Donald C. Cook Nuclear Plant Units 1 and 2  
RESPONSE TO NUCLEAR REGULATORY COMMISSION REQUEST FOR  
ADDITIONAL INFORMATION  
REGARDING LICENSE AMENDMENT REQUEST,  
"REACTOR COOLANT PUMP SEAL LEAK-OFF TWO-PHASE FLOW"  
(TAC NOS. MB0154 AND MB0155)

### RESPONSE TO NUCLEAR REGULATORY COMMISSION STAFF REQUEST FOR ADDITIONAL INFORMATION REGARDING LICENSE AMENDMENT REQUEST REACTOR COOLANT PUMP LOSS OF SEAL INJECTION

**Figure 1**  
**Seal Leak-Off Temperatures Following a LOSI**

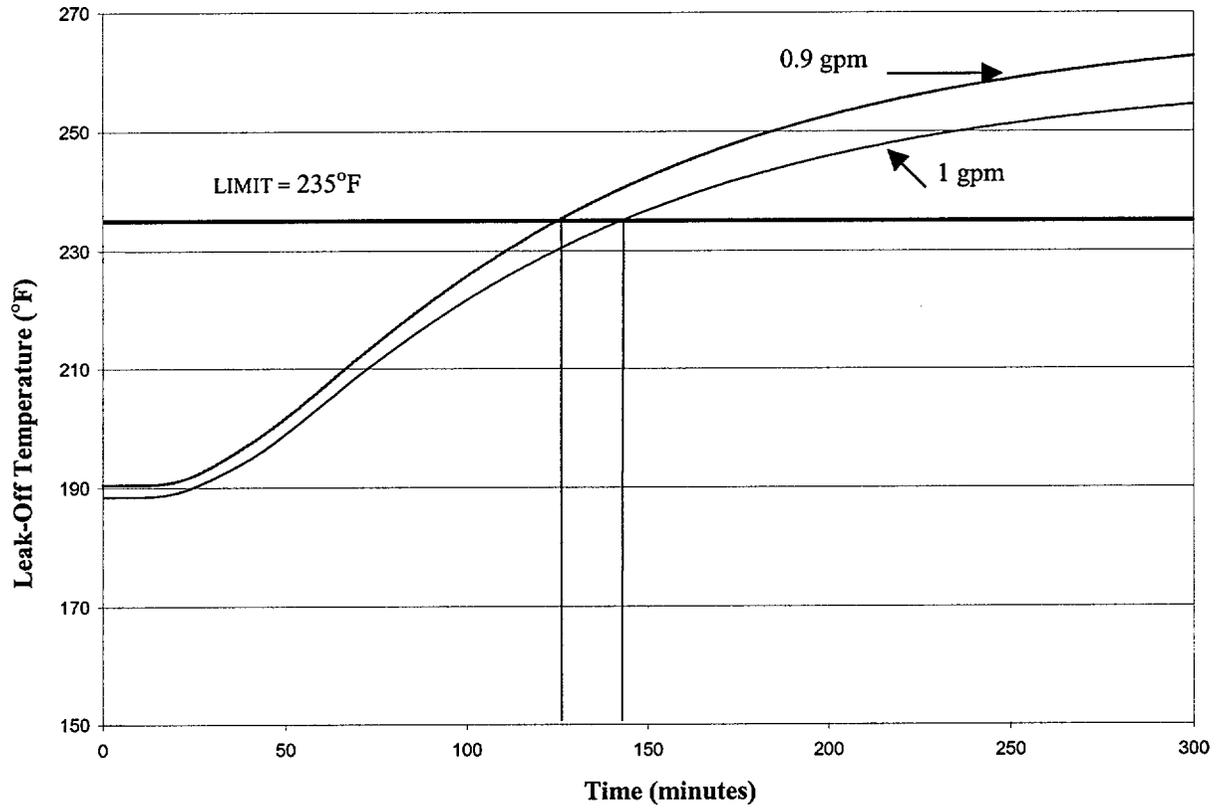
“Please provide justification for no action when reactor coolant system (RCS) temperature is less than 350°F.”

Analyses have been performed to determine the No. 1 seal leak-off temperature following a LOSI for an RCS temperature of 350°F. The analyses were performed for a range of seal leak-off flows (1 to 1.5 gpm), CCW flows (20 to 30 gpm), and CCW inlet temperatures (105 to 120°F). Each case was also analyzed with the RCP running and the RCP not running. The maximum seal leak-off temperature for a leak-off flow of 1 gpm, RCP not running, CCW flow of 20 gpm, and CCW inlet temperature of 120°F was less than the vendor recommended limit of 235°F. The results with the RCP not running are used since the high RCP leak-off-temperature alarm point is 185°F and the RCP will be tripped when the leak-off temperature exceeds this value. Thus, the RCP will not be running at leak-off temperatures above 185°F (the LOSI analyses assume that the RCP will not be running for all cases that result in seal leak-off temperatures over 185°F).

Since the previous analyses did not consider a potential 0.9 gpm seal leak-off condition, additional scoping analyses were performed using a seal leak-off flow of 0.9 gpm and the same range for CCW flow and temperature. The highest leak-off temperature of 231°F is observed for a leak-off flow of 0.9 gpm with a CCW flow of 20 gpm, the CCW inlet temperature at 120°F, and the pump not running. Again, the maximum temperature is less than 235°F and no action is required.
